ARVIN PARSHALL FLUME PROJECT  
ADDENDUM 2

Issue Date: September 26, 2018

CONCRETE PIPE SUPPORT

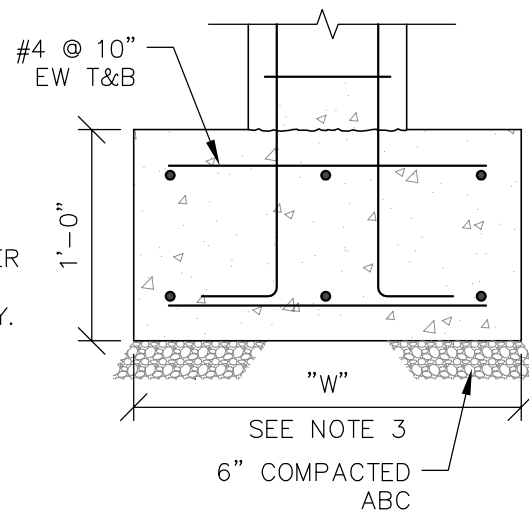
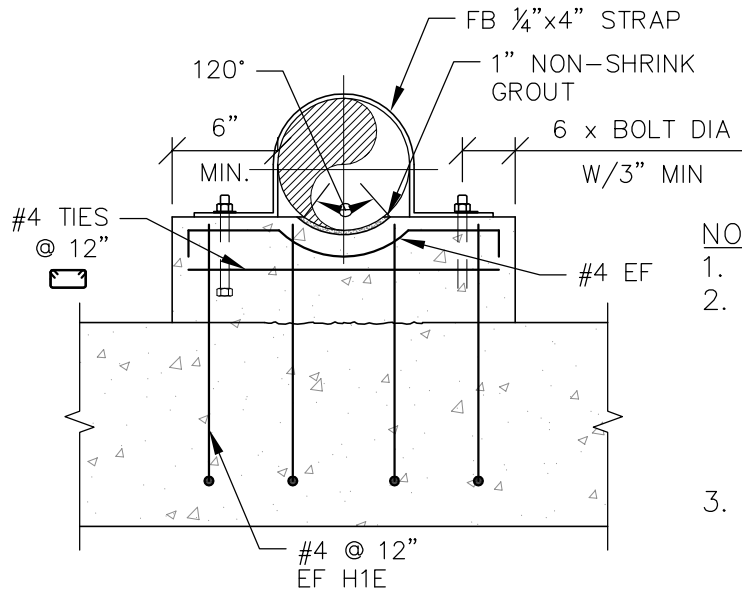
The above grade ductile iron piping downstream of the parshall flume appears to be unsupported for approximately 20 linear feet. Please advise if any pipe supports will be required for this section of piping.

*Yes. Please provide two pipe supports for the ductile iron piping downstream of the Parshall Flume, which are equally spaced to support the pipe - between the flume and the point where the pipe enters the ground. Attached is a detail for the pipe support.*

1. MAX VERTICAL LOAD = 6000 POUNDS.
2. IF SUPPORT IS SUBMERGED OR LOCATED BELOW THE TOP OF WALL IN WATER BEARING STRUCTURE, MATERIAL FOR ANCHOR BOLTS AND STRAP SHALL BE STAINLESS STEEL. IN ALL OTHER AREAS, STRAP SHALL BE HOT-DIP GALVANIZED STEEL UNLESS OTHERWISE INDICATED ON THESE DRAWINGS.
3. THE WIDTH OF THE FOOTING "W" = 2'-6". THE LENGTH OF THE FOOTING = "PIPE DIA" + 2'-0".
